Access Compliance Report

Public Rights-of-Way

(Curb Ramps)

Intersection ID: 44118	Main Street: CORAM_PL	Cross Street: RIDING_HILL_AV	Location: S
ADA ID: 3ED9973CFB43	Ramp Type: PerpDiag	Initial Pass/Fail: Fail	Overall Compliance: No
		Severity Score: 10

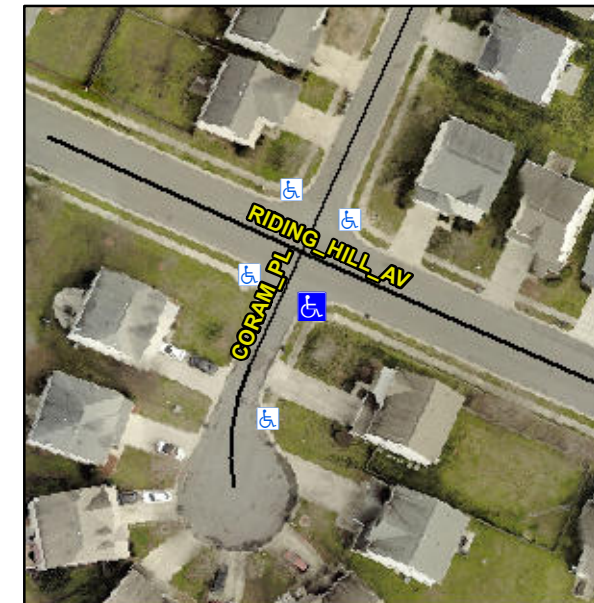
Not Found, R304.5.1, R304.5.3

Compliance	Description	Data	Compliance	Description	Data
N/A	Ramp Length (in)	48.0	Yes	Ramp Slope (%)	7.4
No	Ramp Width (in)	39.0	No	Ramp XSlope (%)	3.5
N/A	Flare Type LT	N/A	N/A	Flare Type RT	N/A
N/A	Flare Slope LT (%)	N/A	N/A	Flare Slope RT (%)	N/A
N/A	Flare Traversable LT?	N/A	N/A	Flare Traversable RT?	N/A
N/A	Landing Length (in)	N/A	N/A	DWS Provided?	N/A
N/A	Landing Width (in)	N/A	N/A	DWS Contrast?	N/A
N/A	Landing Slope (%)	N/A	N/A	DWS Length (in)	N/A
N/A	Landing X Slope (%)	N/A	N/A	DWS Full Width?	N/A
N/A	Landing Curb? (Y/N)	N/A	N/A	DWS Offset (in)	N/A
N/A	Shared Landing?	N/A			
N/A	Gutter Ponding?	N/A	N/A	Gutter Slope (%)	N/A
N/A	Gutter Lip Ht (in)	N/A	N/A	Gutter X Slope (%)	N/A
N/A	Painted X Walk1?	No	N/A	Painted X Walk2?	No
	X Walk 1 Direction	To NE		X Walk 2 Direction	To NW
N/A	X Walk 1 Width (in)	N/A	N/A	X Walk 2 Width (in)	N/A
	X Walk 1 Slope (%)	2.2		X Walk 2 Slope (%)	3.9
	X Walk 1 X Slope (%)	4.1		X Walk 2 X Slope (%)	0.3

Remove & Replace Curb Ramp With Two New Directional Ramps or Equivalent.
